**RE: Legacy Apartments - Oakland Roadway
Supplemental Drainage Analysis
Engineer's Stamp Date: 5/11/18
Hydrology File: C18D064B**

**RE: Oakland Roadway Inlet Analysis
Legacy Apartments**

OAKLAND INLET ANALYSIS

GRATING CAPACITIES FOR TYPE 'A' , 'C' and 'D'

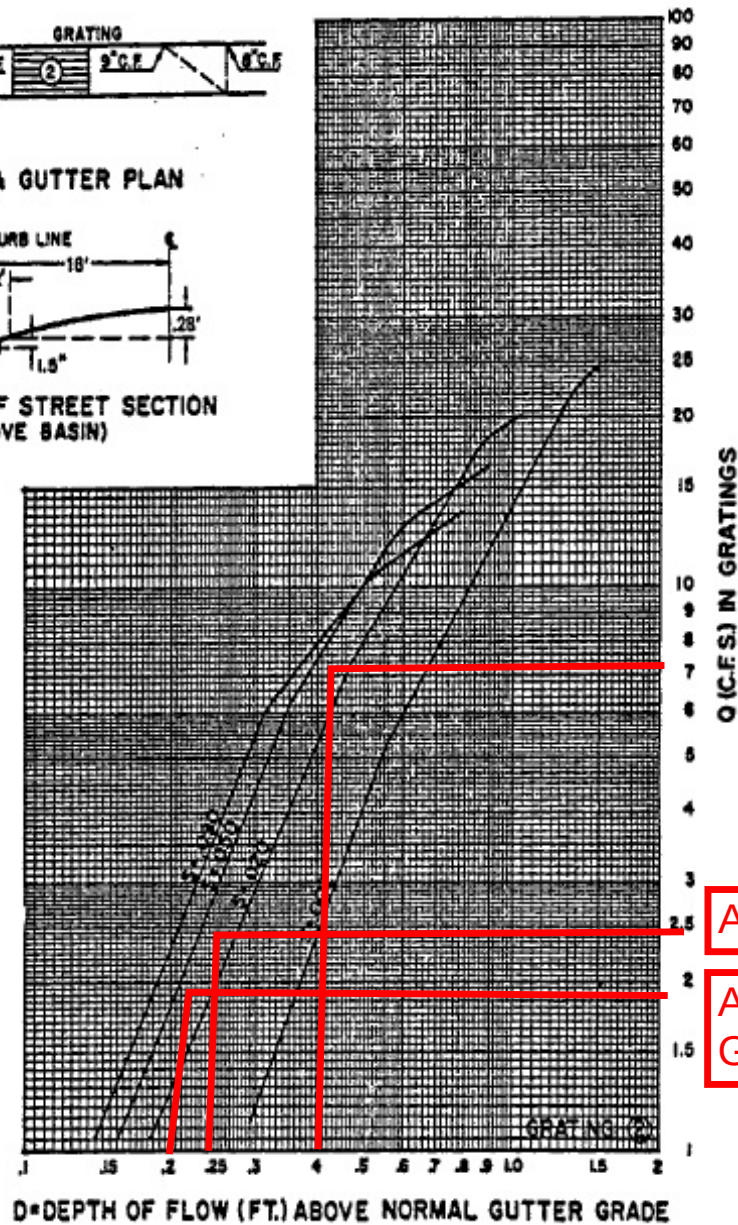
2. AP1 Is a double "C" inlet and you have calculated the grate would capture 14 CFS however you used the nomograph for a single inlet "A", "C", and "D". Please use the nomograph for a double inlet. The amount captured should be a lot less than 14 cfs. AP3 is also a double "C" inlet. However by the time all the surface drainage reaches AP3, it is captured by this inlet.
